6.5. Blind Spot Information Dynamic Test

Figure 1
Dynamic tests

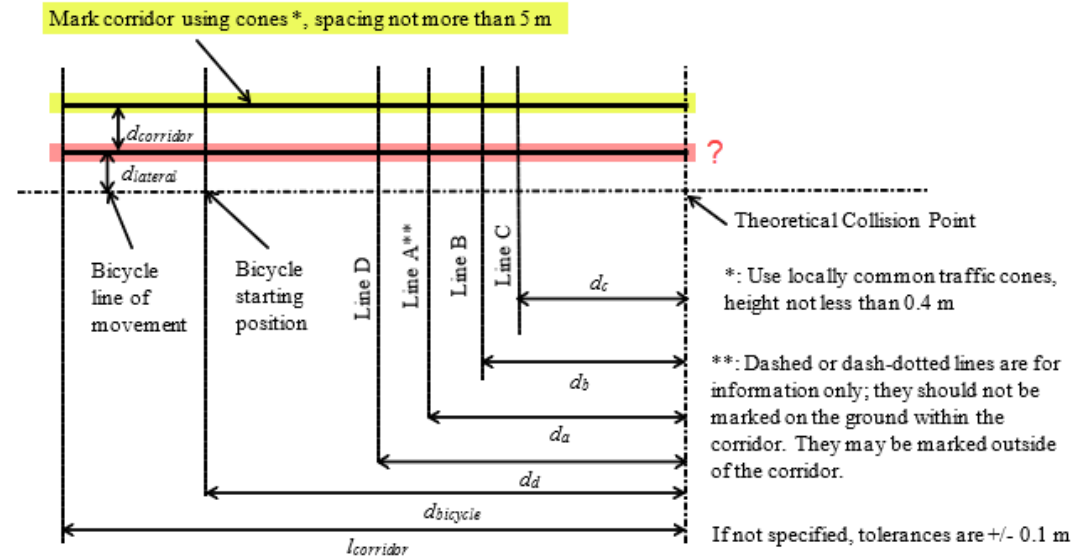
- Does the arrow in the picture 1 mean that the cones shall be only on the far side of the vehicle?
- How can one form the corridor with the bicycle dummy (6.5.1.) as it shall be 1,25 or 1,45 m away from the corridor?
- If the cones are only on the far side, there will never be a possibility to get an information signal when passing the cones. So why 6.5.8.? And why having a certain height of the cones (figure 1)?
- If the cones shall be also on near side they partly hide the view to the bicyclist, see next slide. That is a problem, especially as the system has difficulties to track the bicycle that far behind because of sensor limits.
